Willow Rock Energy Storage Center (21-AFC-02)

Responses to California Unions for Reliable Energy (CURE) Data Request Response Set 2

Data Request Number 43 through 140

Figure DR82-1 Proposed Preliminary Tower Map

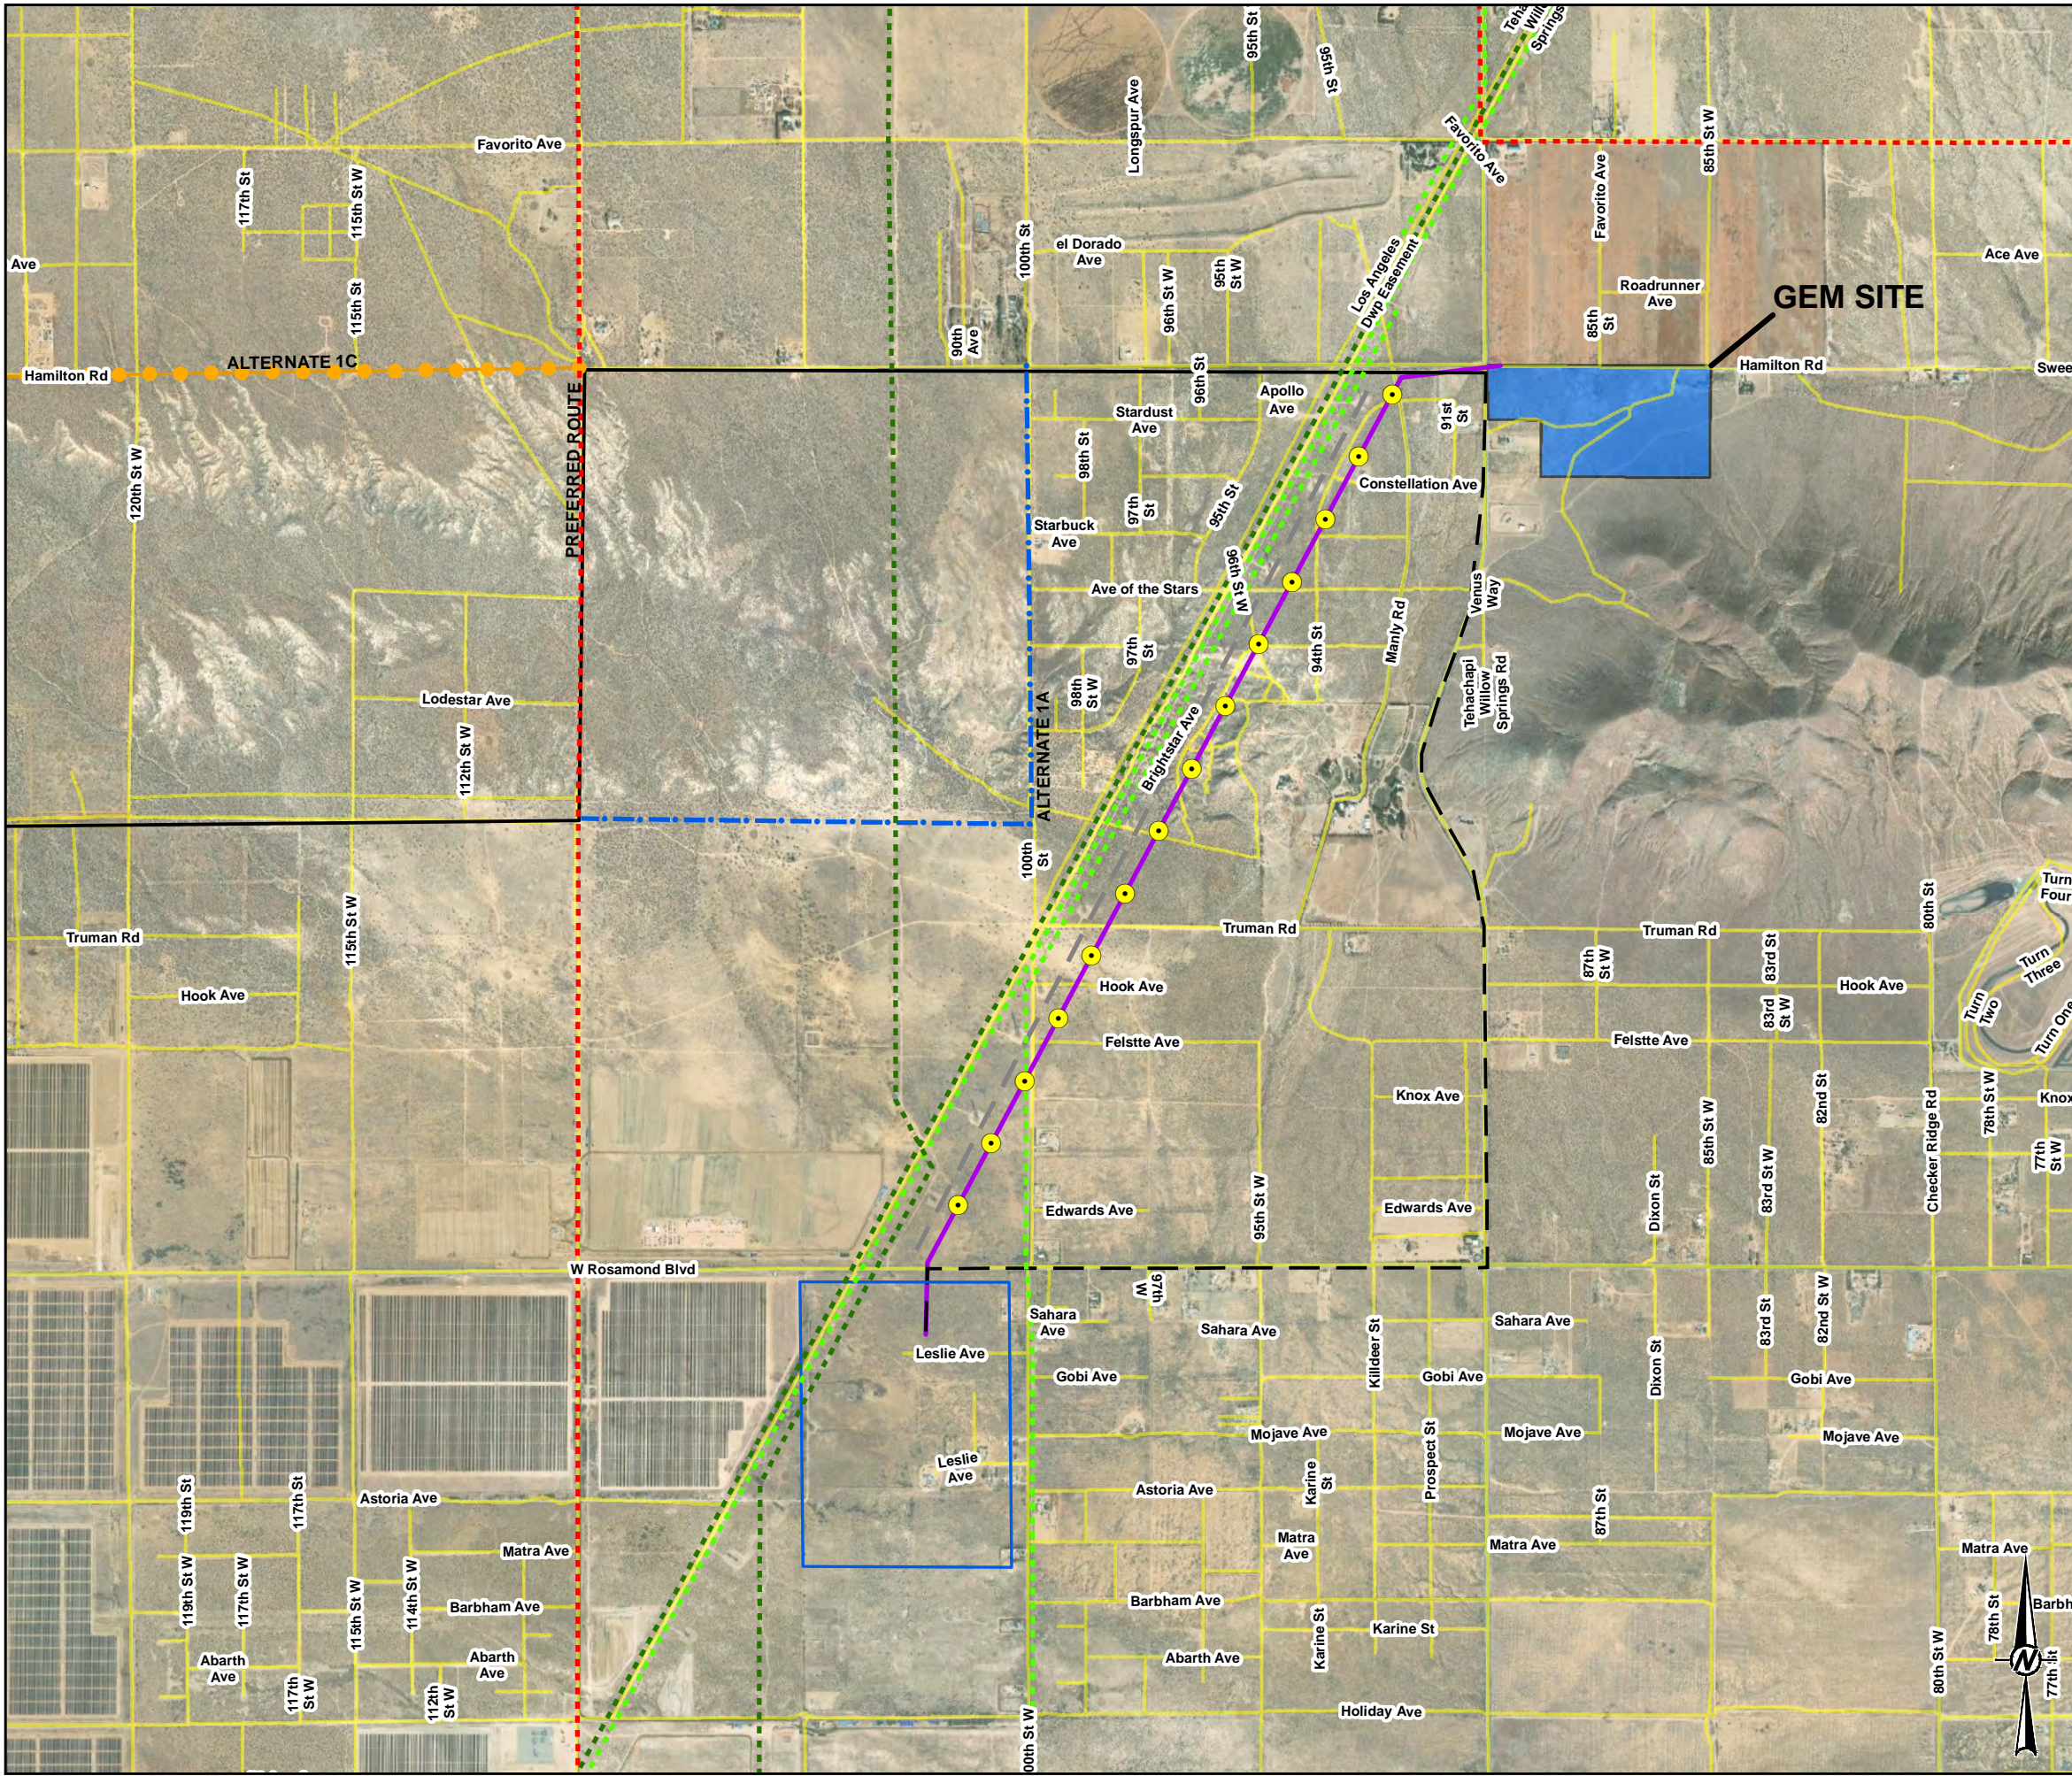
Provide aerial imagery of any and all existing access and spur roads associated with Alternate Routes 2A and 2B. If none exist, please provide support for the claim that only existing access roads would be used for Alternate Routes 2A and 2B.

Response: Refer to Attachment CU DR82-1. The figure demonstrates that there are numerous pre-existing access roads to support construction at the tentative pole locations along the transmission line route along proposed Route 2A. Route 2B is adjacent to an existing roadway and no additional access roads are anticipated to be required. Please note that this response is subject to possible change following completion of Project optimization.

California Electric Infrastructure

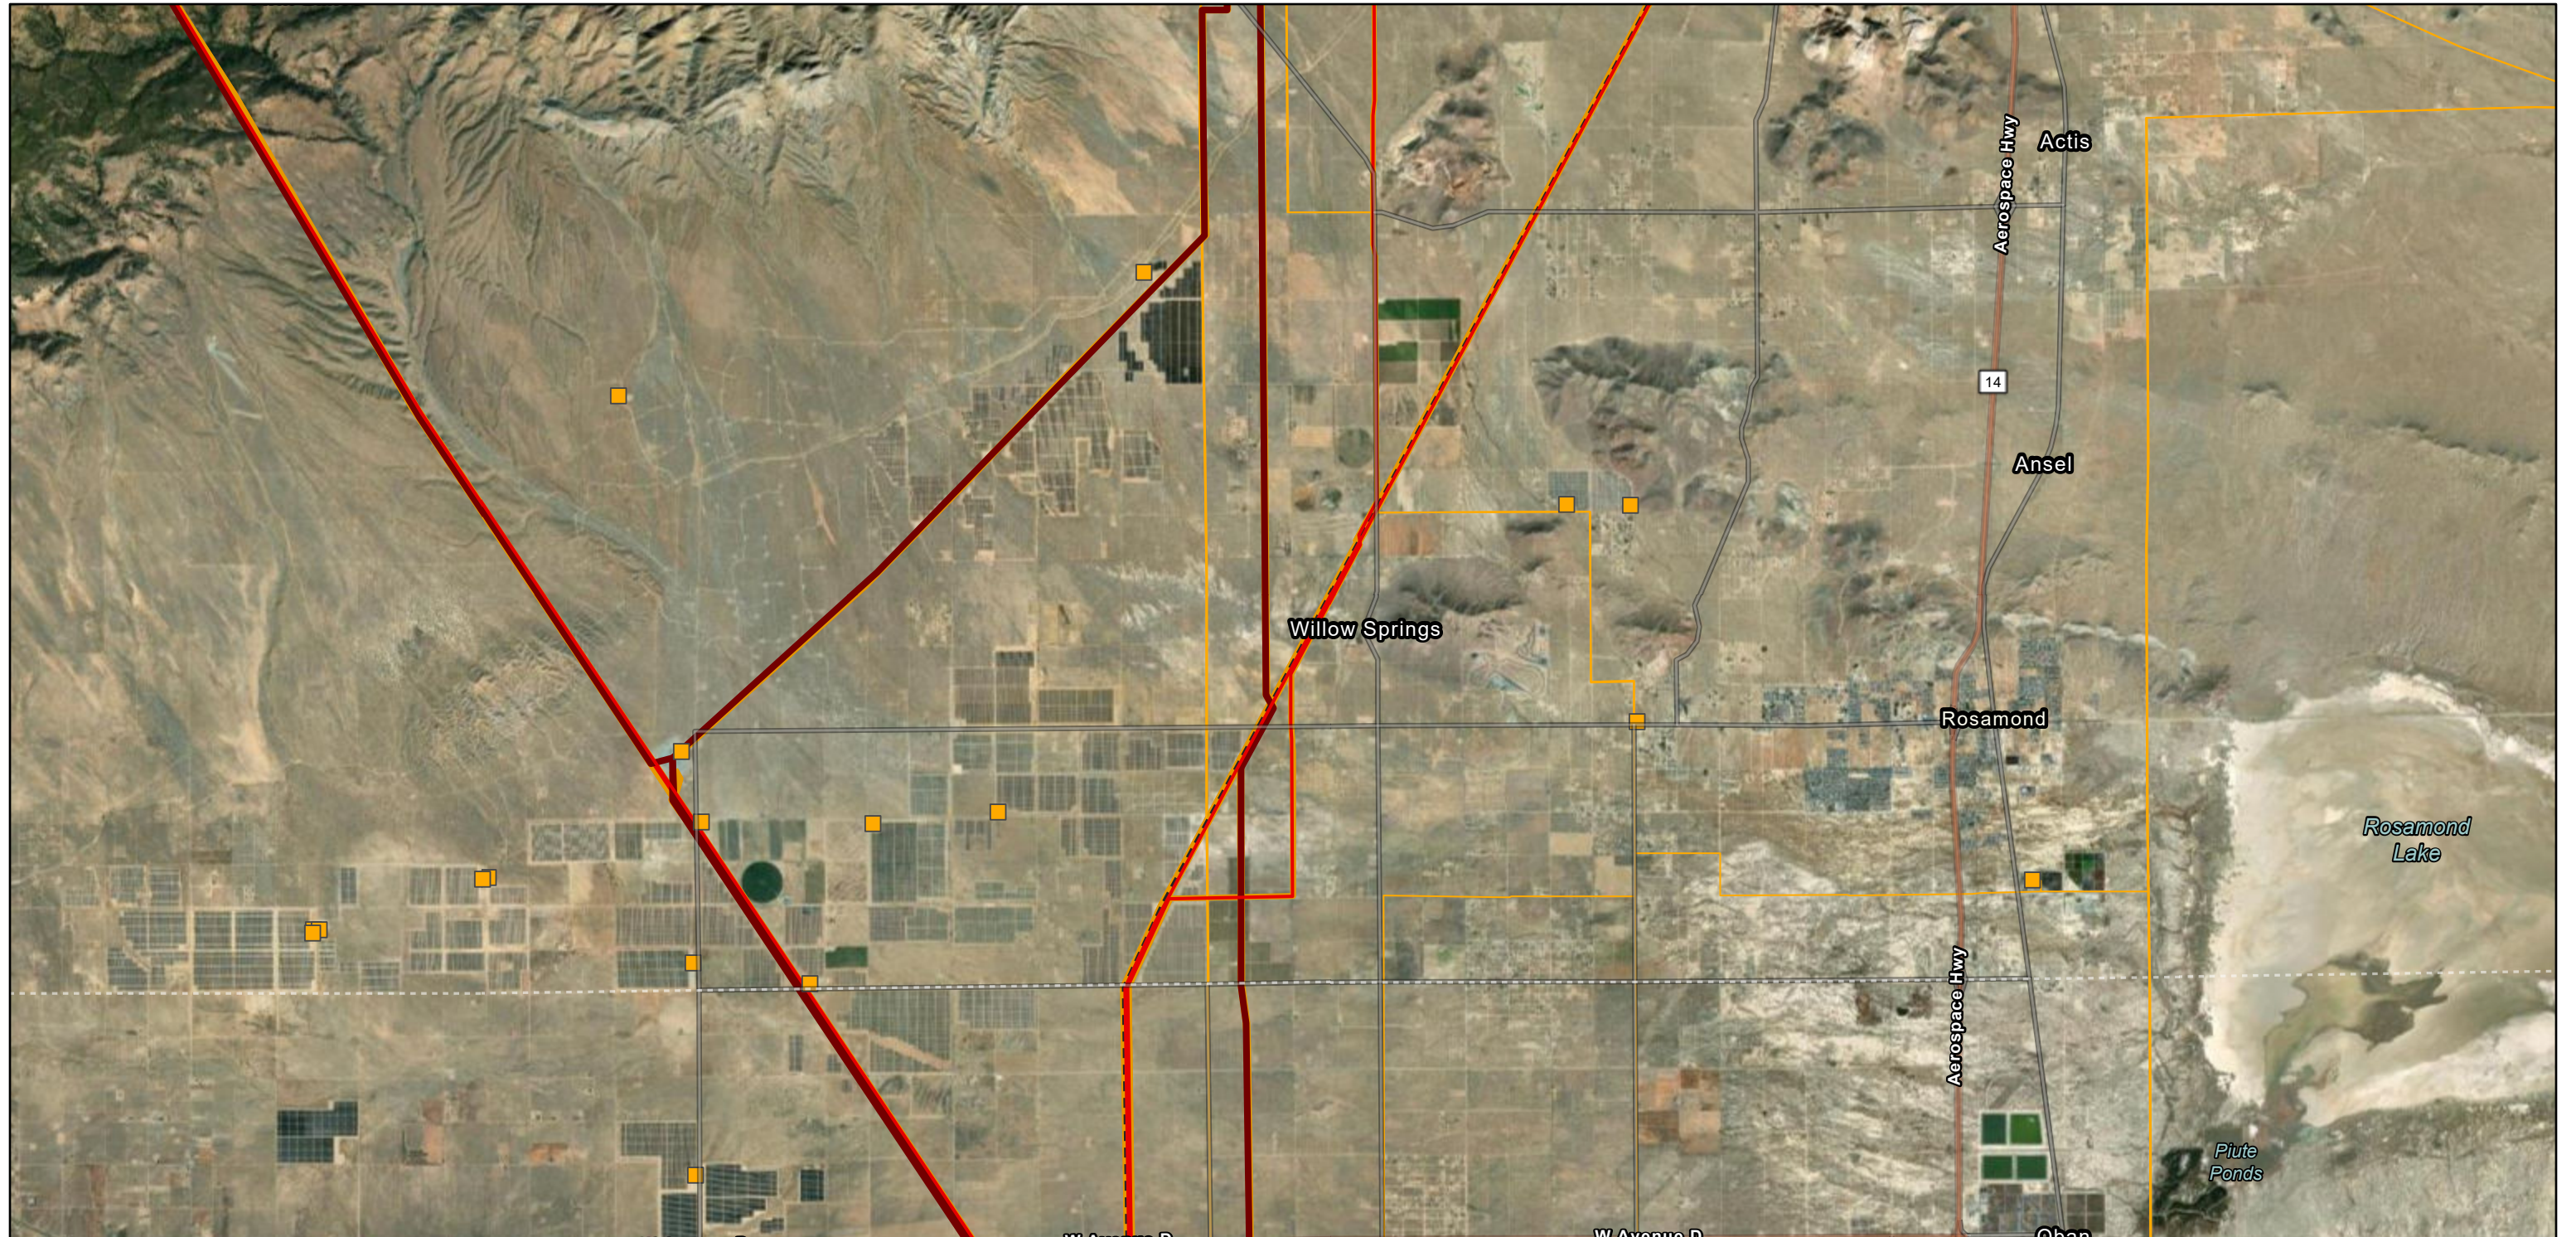
Please provide images from the CEC's map of California Electric Transmission Lines or any other evidence to show existing power lines 5260-036acp 15 along the gen-tie routes depicted on AFC Figure 1-4 (TN 240751-2).

Response: Refer to Attachment CU DR94-1 for a map depicting existing transmission lines in the Project vicinity created using the California Energy Commission's publicly available California Electric Infrastructure App accessible at <https://cecgis-caenergy.opendata.arcgis.com/apps/CAEnergy::california-electric-infrastructure-app/explore>. Accessed online 053123.
